Remarks:

Reconsideration of the application is requested.

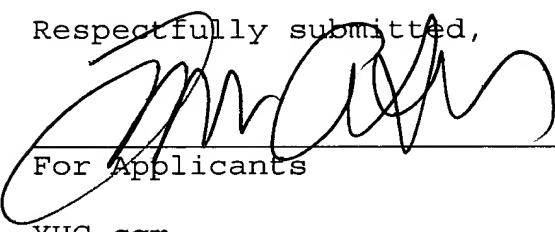
In the section entitled "Specification" on page 2 of the above-identified Office action, the specification has been objected to because of informalities.

Appropriate correction has been made. More specifically, the reference sign for a "lateral sheet edge" has been changed to "31'". The corresponding Fig. 5 has also been amended.
